CitiPower/Powercor Technical Standards Update for July 2021

DE011, DE121 & DE370 – standards update

DC111, DC121, EA001, EC031, EC131, EC201, EF002, EF003, EF007 and EF031 – standards update

FA081, FB111, FB121, FB131, FB133 and FM011 – standards update

Figure 1 – Optional IPC

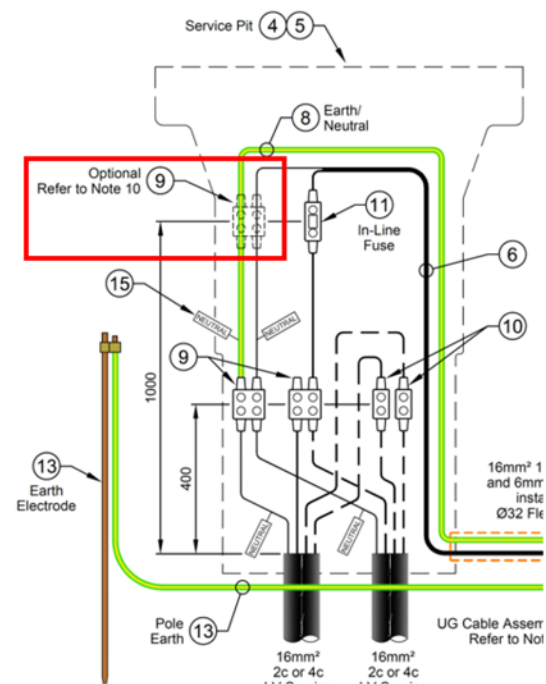
- Technical Standards FA081, FB111, FB121, FB131 and FB081 have been updated to clarify when an optional IPC is required.
- Technical Standard FB133 have been updated to clarify when a dedicated service pit is not required.

- Feedback from the field audit group advised that the standards showed a third 4 port IPC that was not always required. To clarify its use, a note has been added and the third 4 port IPC was shown as optional.
- Feedback from the field audit group also advised that further clarification was required around the use of dedicated service pits.
